Safety Evaluation Report

related to the operation of
Midland Plant,
Units 1 and 2

Docket Nos. 50-329 and 50-330

Consumers Power Company

Figure 2.1 Plan of permanent dewatering system
 (Source: Applicant's letter of April 19, 1982)

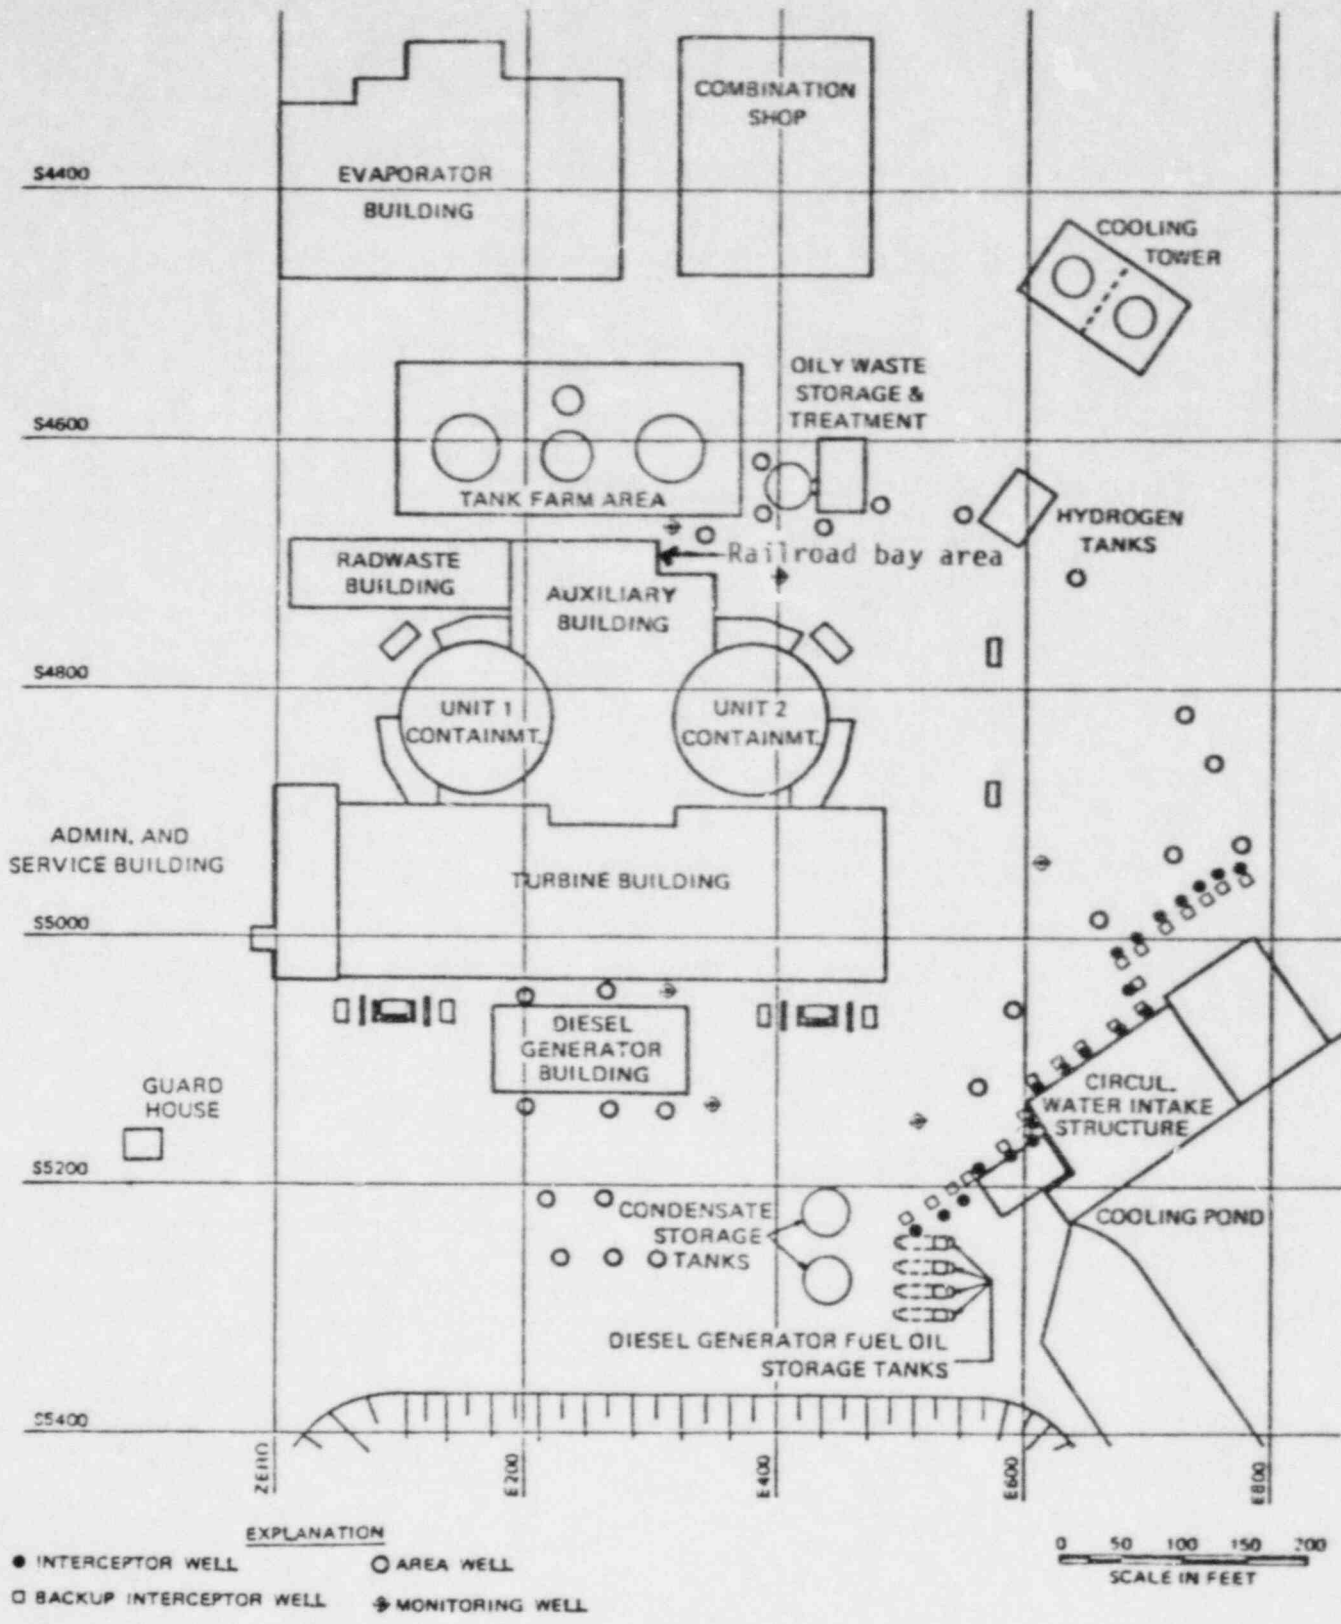
As described in Section 2.4.6.2 of the SER, the applicant stated that the dewatering system is not seismic Category I because it is not required to operate during or after an SSE. The applicant estimated that in the unlikely event of a complete failure of the dewatering system, it would take at least 60 days before water levels below the DGB and the RBA would rise to el 610 ft MSL. This would allow sufficient time to repair and/or replace any damaged portion of the dewatering system. To verify the time before water levels reach el 610 ft MSL, the staff requested and the applicant conducted a recharge test. In conducting this test, water levels in wells surrounding the DGB were lowered to el 595 ft MSL or below, except in areas where impervious soil conditions caused perching of the water at levels slightly higher than this elevation. All dewatering well pumps were then shut off and water levels were allowed to rise normally for a period of 60 days. The staff was informed that the highest water level recorded in the vicinity of the DGB was el 608.95 ft MSL, which occurred in Well COE-10. Figure 2.2 of this SSER shows the locations of Well COE-10 and other wells monitored during the recharge test. The applicant reasoned that water levels at the RBA would rise more slowly because the RBA is further away from the source of recharge, the cooling pond. On the basis of this information, the staff agreed in the SER with the applicant's conclusion that it would take at least 60 days before water levels would rise to el 610 ft MSL beneath the DGB. The recharge test results regarding the effects on water levels in the RBA were not available when the SER was published; however, the staff agreed with the applicant's reasoning that water levels at the RBA would rise more slowly than at the DGB. As discussed below, the results of the dewatering test have shown that the groundwater rise to el 610 ft would be achieved in less than the anticipated 60 days, and water levels at the RBA actually rose at a slightly faster rate than at the DGB.

Subsequent to publication of the SER, by a letter from the applicant dated June 7, 1982, the staff received the applicant's report on the recharge test. Enclosure 1 of that letter shows that water levels in most of the wells monitored in the vicinity of the DGB during the recharge test were at elevations below 595 ft MSL

Figure 2.2 Observation wells at critical structures monitored during recharge test (Source: Applicant's letter of April 19, 1982)

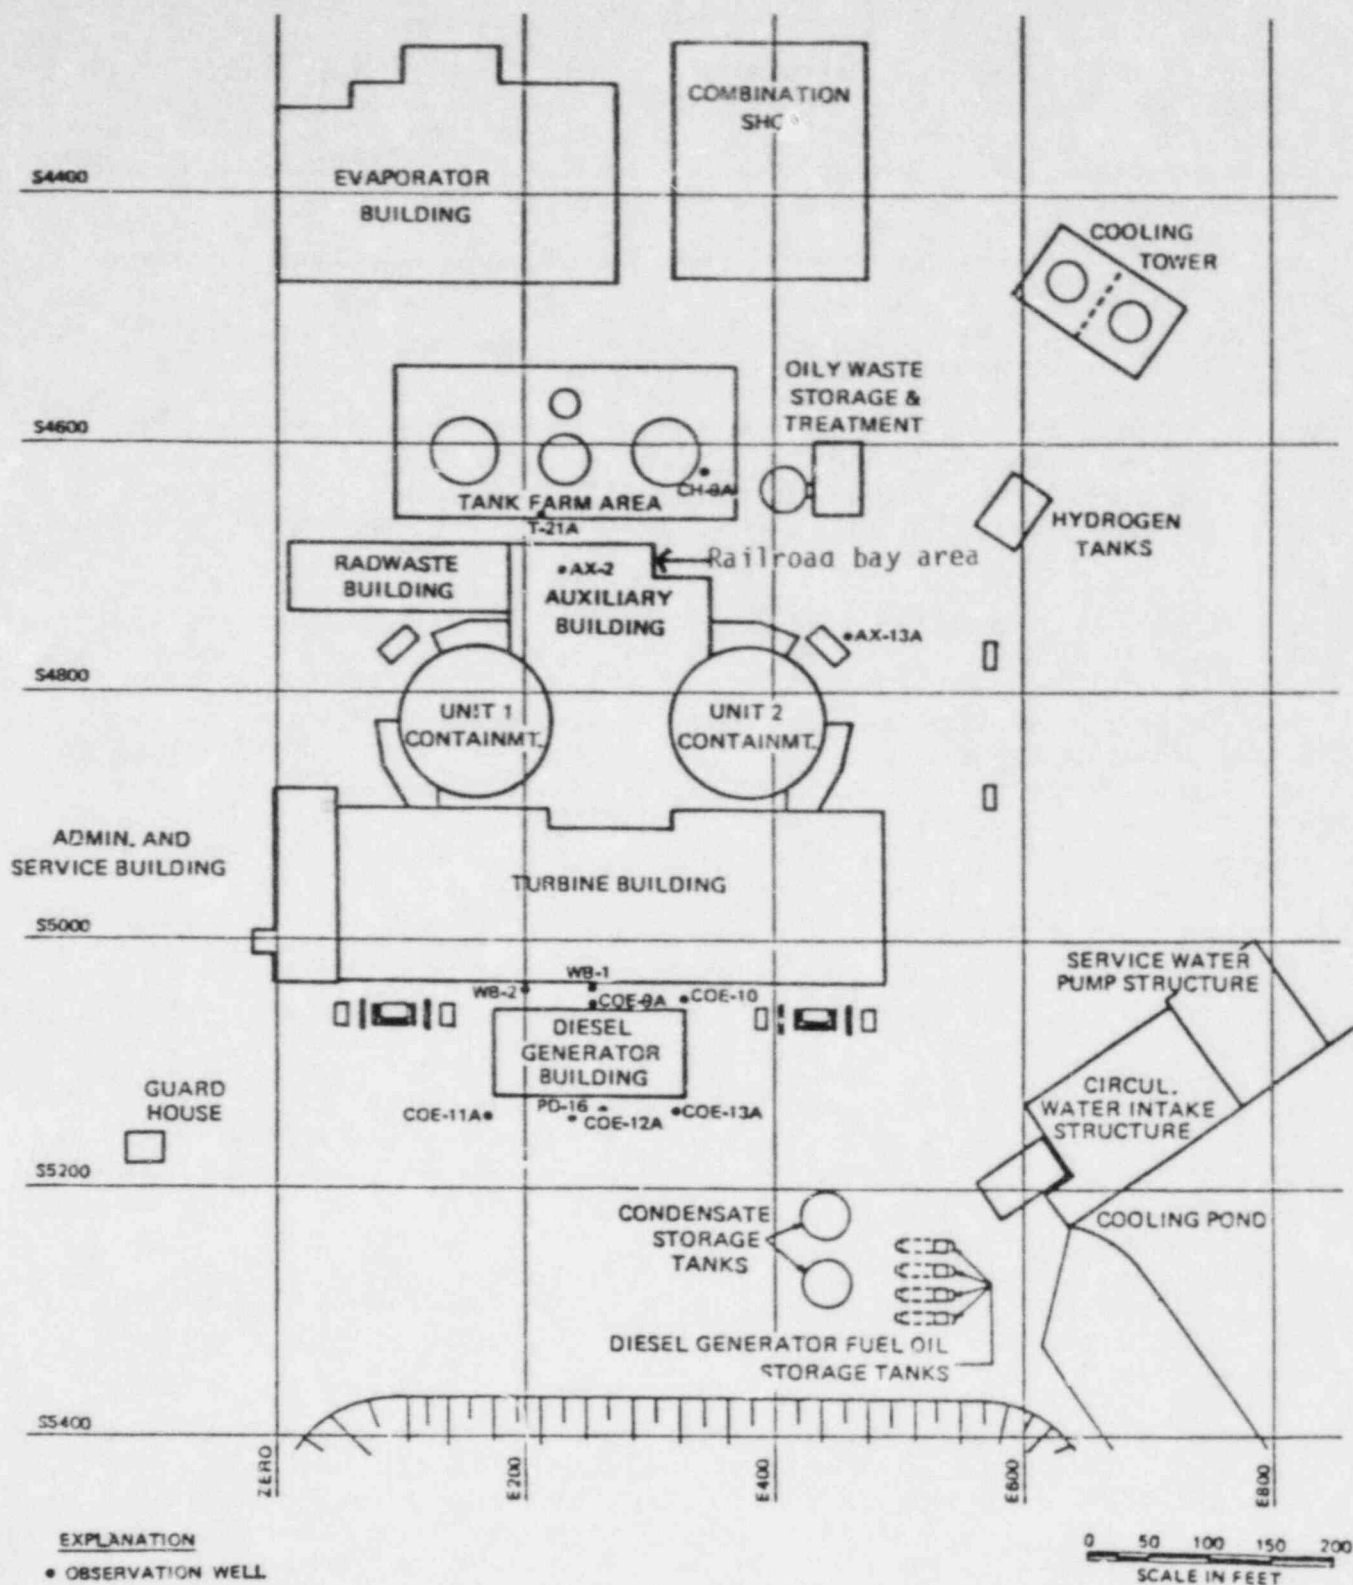
when the recharge test was initiated; therefore, the applicant's earlier conclusion that there is a minimum recharge time of 60 days is valid only if groundwater levels are lowered below el 595 ft MSL, as was done before the recharge test. Because the design-basis elevation of the dewatering system is 595 ft MSL, the minimum recharge time at the DGB appears to be only about 52 days.

On March 11, 1982, about 35 days after the start of the recharge test, a high-pressure water line below the auxiliary building was ruptured by a boring. Water from this broken water line flowed until March 17, 1982, when the applicant was able to isolate the line break and stop the flowing water. The applicant states that one well located within the RBA (Well AX-2, see Figure 2.2) was flooded by the broken water line; therefore, the water level in this well does not represent a saturated water level within the backfill. The applicant further states that water levels in three other RBA wells also may have been influenced by the broken water line.

The staff also concludes that the broken water line may have resulted in an increased rate of groundwater rise in some other RBA wells, although the increase was not as apparent as it was in Well AX-2. To determine what the recharge rate would have been at the RBA had there not been a water-line break, the staff compared the RBA well hydrographs with other hydrographs for wells located just east of the RBA that did not appear to have been affected by the broken water line. These well hydrographs showed a rate of rise of about 0.41 ft/day during the recharge test. A comparison of this rate with that in RBA wells showed that after the water-line break was repaired, water levels in the RBA wells also rose at a rate of about 0.41 ft/day. This rate is slightly higher than the groundwater rate of rise for the DGB, where groundwater levels

Figure 2.4 Areas committed to permanent dewatering
(Source: FSAR Figure 2.4-47)

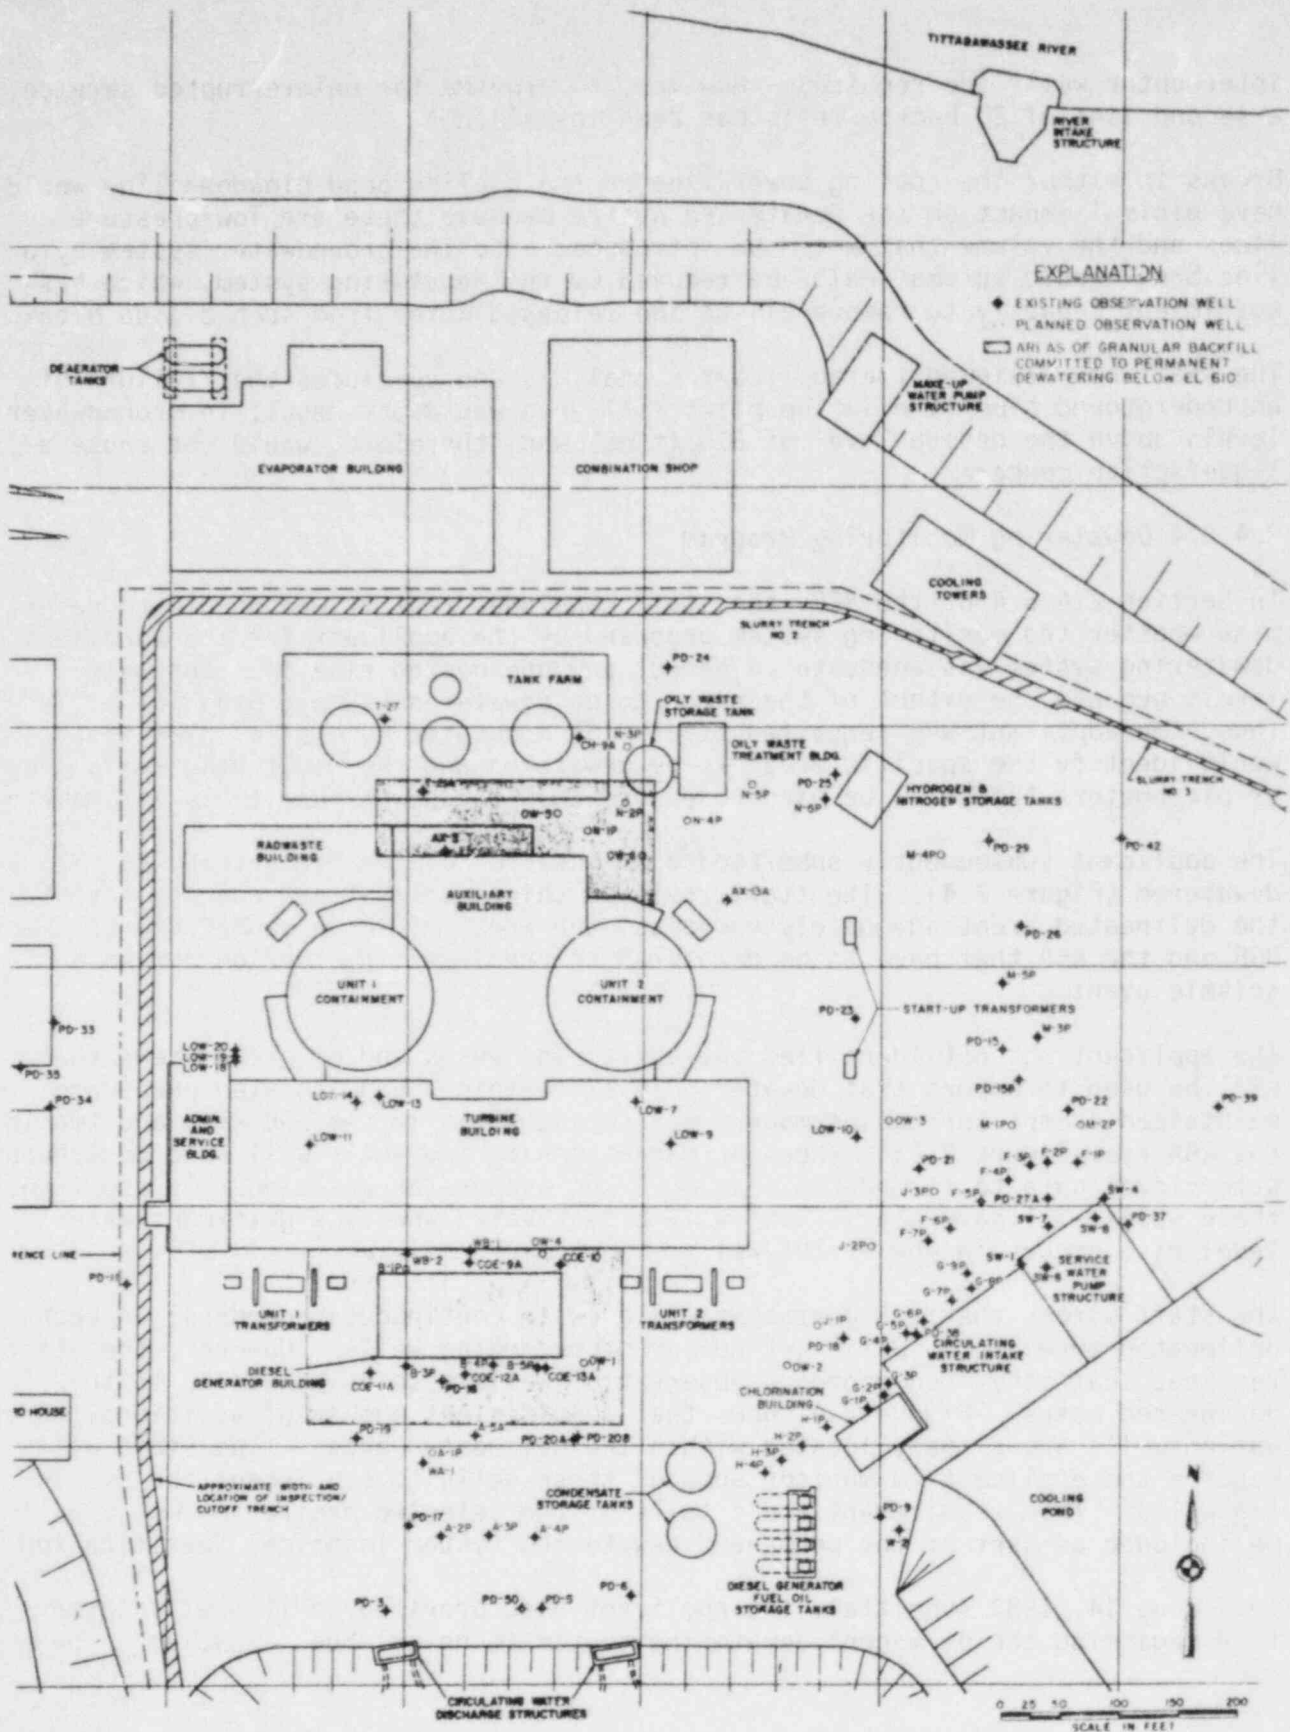
The applicant subsequently submitted a delineation of the areas that will be dewatered (Figure 2.4). The staff reviewed this submittal and concluded that the delineated areas adequately encompass the areas of loose sands beneath the DGB and the RBA that have to be dewatered to preclude liquefaction during a seismic event.

The applicant has not identified the monitoring wells and/or piezometers that will be used to ensure that dewatered levels within the delineated areas are maintained except for two permanent monitoring wells in the DGB area and two in the RBA (see Figure 2.1). These permanent monitoring wells will send continuous water-level data to recorders located in the evaporator building. In addition, these wells will have alarms that will be activated when a significant water-level rise occurs in any of the wells.

The staff agrees that two permanent wells (with continuous recorders) in each delineated area are a sufficient number of recording wells. However, the staff requires that other nonrecording observation wells also be monitored in the delineated areas. Figure 2.4 shows that a sufficient number of additional observation wells are already located within the delineated areas. The staff will require the applicant to monitor some of these wells to supplement the recording wells. This requirement and details of the selected monitoring wells will be included as part of the permanent dewatering system Technical Specification.
